PCN-20190311 TE0725LP-01 Flash Change

Company	Trenz Electronic GmbH
PCN Number	PCN-20190311
Title	TE0725LP-01 SPI Flash Change
Subject	BOM change
Issue Date	20190311

This change affects all TE0725LP modules of revision 01: TE0725LP-01

Locate Flash (U7) on backside of PCB:

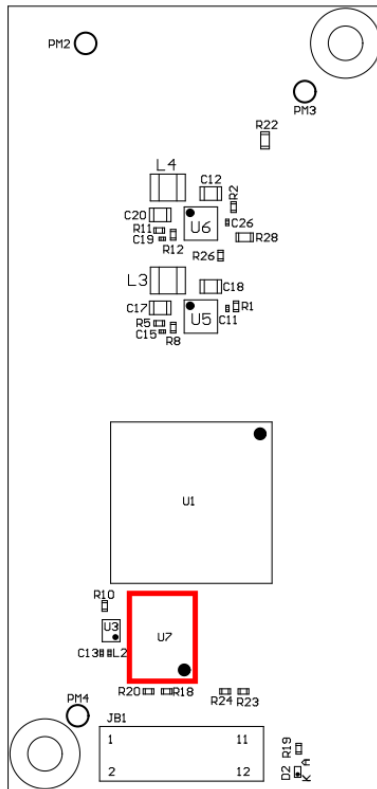
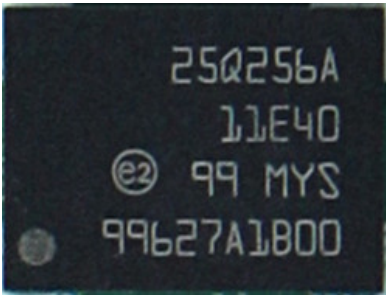
#1 Change SPI Flash from N25Q256A11E1240E to MT25QU512ABB8E12-0SIT

Reason: N25Q256A11E1240E became obsolete.

Impact: Size changed from 256 MBit to 512 MBit. JEDEC ID changed from BB19h to BB20h both with manufacturer ID: 20h.

old	new
N25Q256A11E1240E	MT25QU512ABB8E12-0SIT
